CALL NO. 200
CONTRACT ID NO.
131212 Addendum # 2

Subject: Marshall Trigg County, 121GR13D012 - NHPP 0801 (098)
Letting December 20, 2013

- (1) Revised - Plan Sheets - R2, S2, S134, S183, S184A, S184B, S187, S192, S194, S206, S207, S207A, S207B, S208, S208A, S208B, S209, S209A, S210, S211, S212, S213, S216, S217, S260, S261, S274
- (2) Revised - Cover Page - PAGE 1 of 403
- (3) Revised - Completion Dates - Page 4 of 403
- (4) Revised - Multiple Notes - Various Pages
- (5) Revised - Bid Items - Page 397-403 of 403
- (6) Delete - Pages 27thru44, 216thru233, 207thru215, 234thru238 of 403

SINGLE HANGER CONNECTION

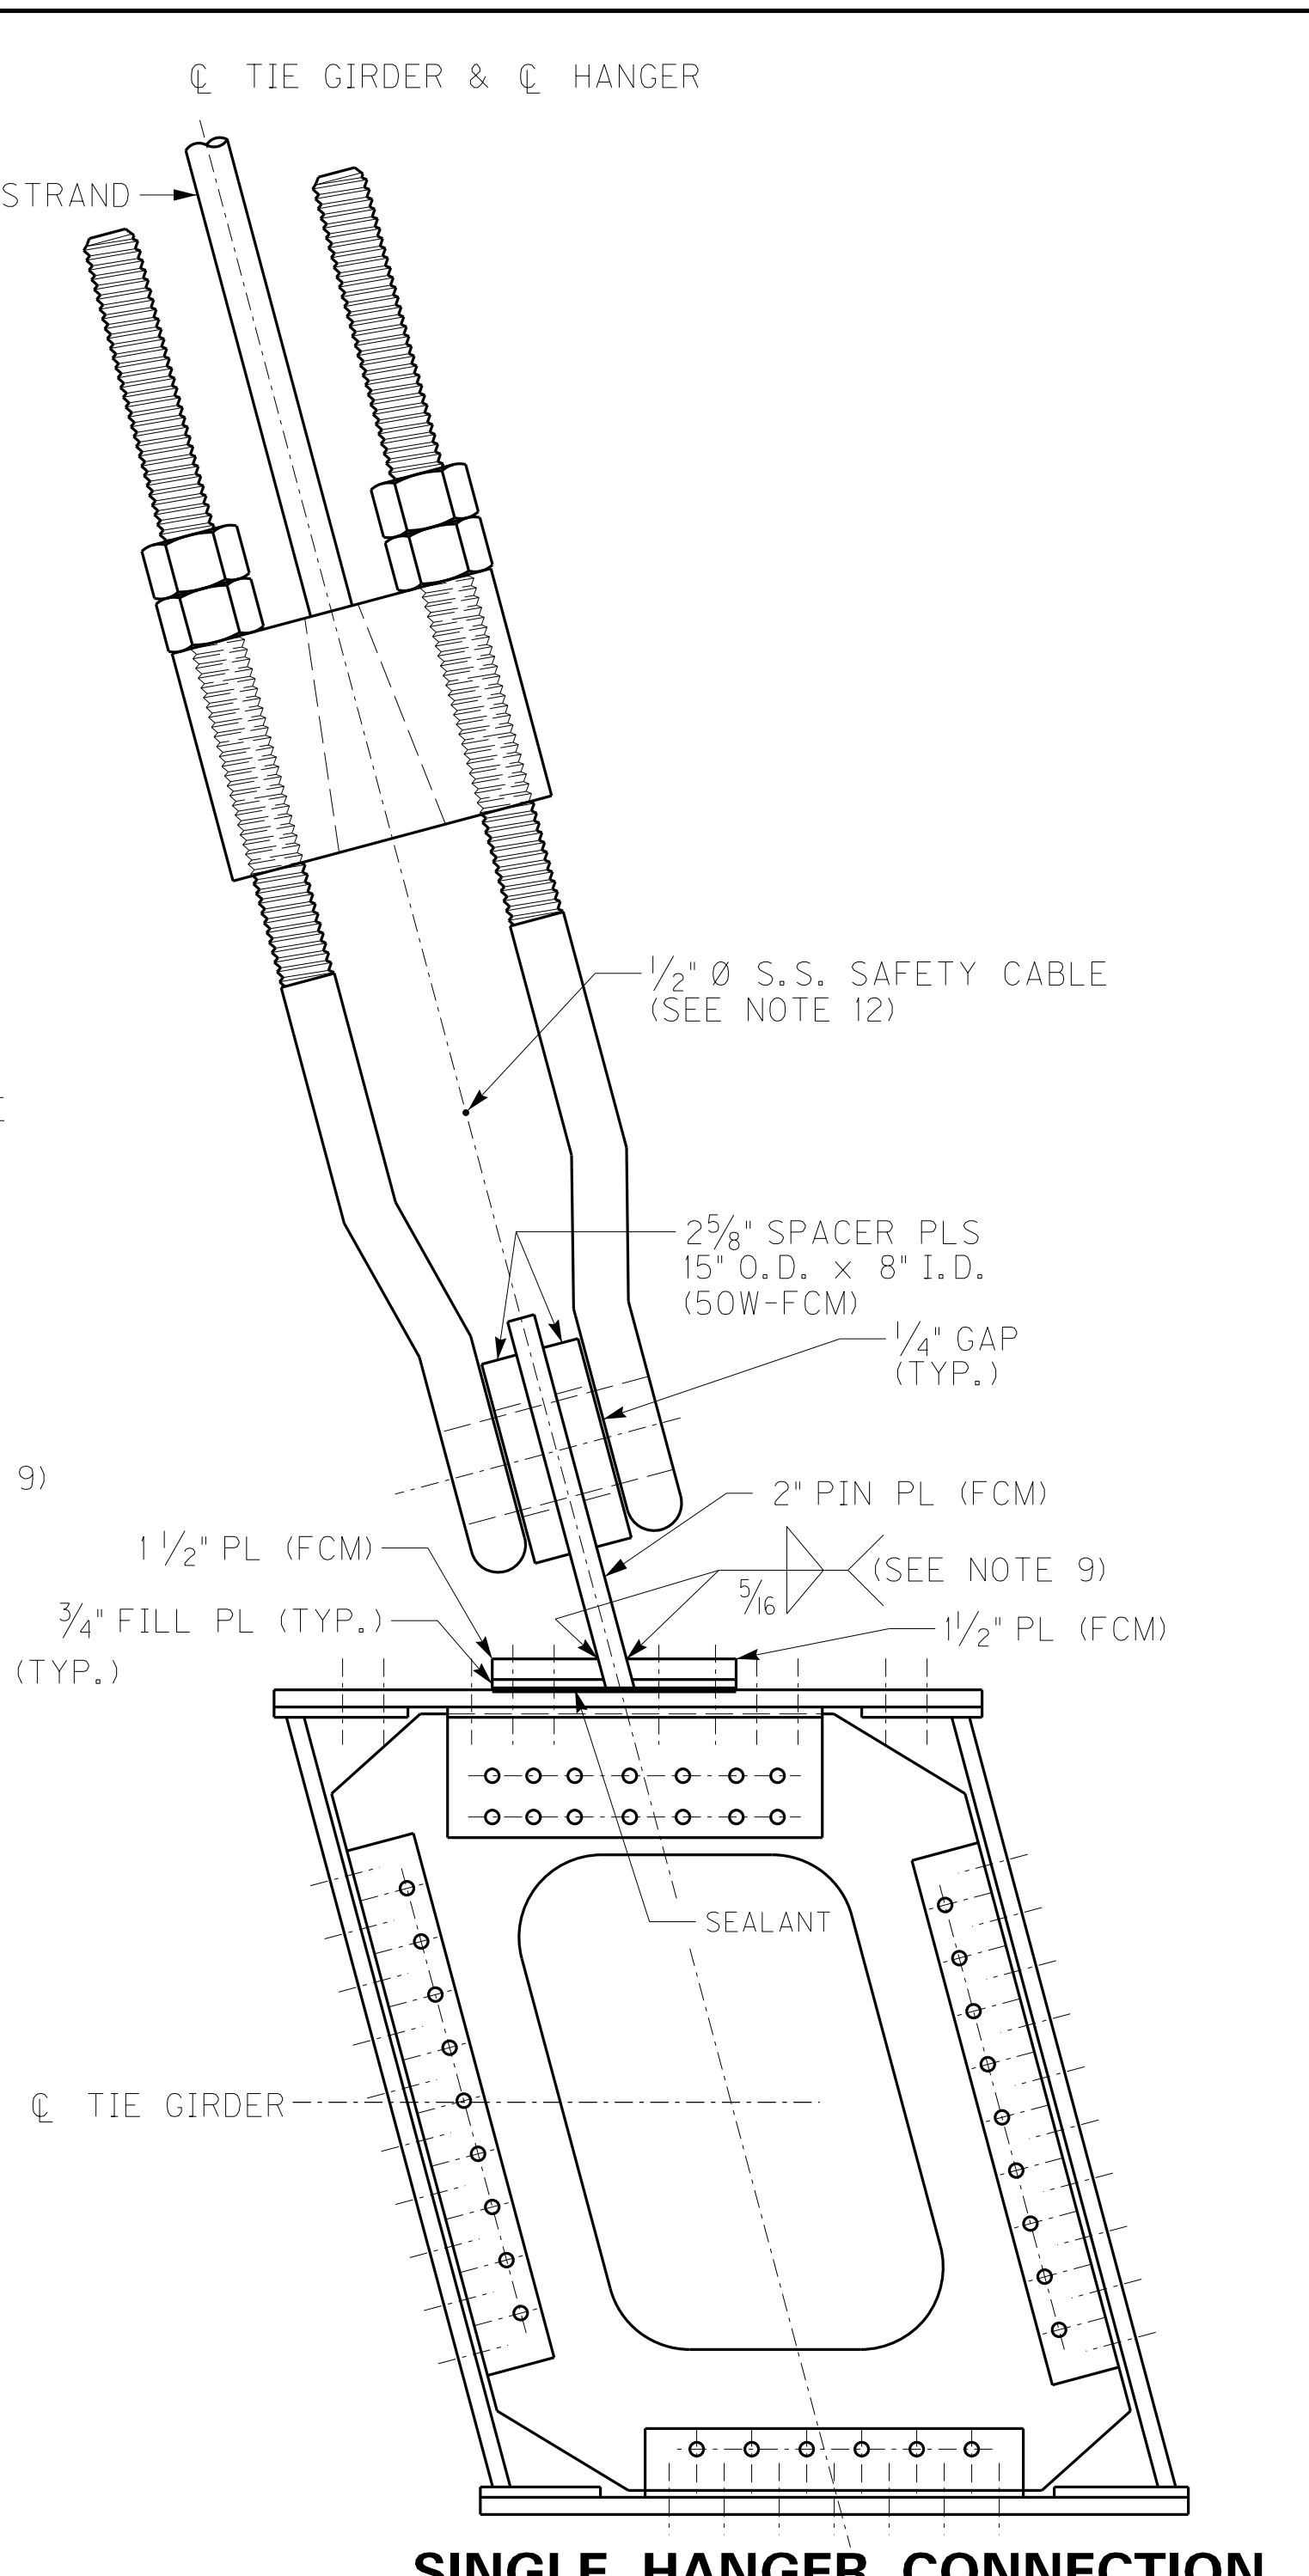
△ ADDED HPS	12/06/13
△ ADD FCM TO PIN PL, CONN. PL & SPACER	11/25/13
REVISION	
DATE: NOVEMBER 15, 2013	CHECKED BY
DESIGNED BY: DMB	RTH
DETAILED BY: MJD	DMB
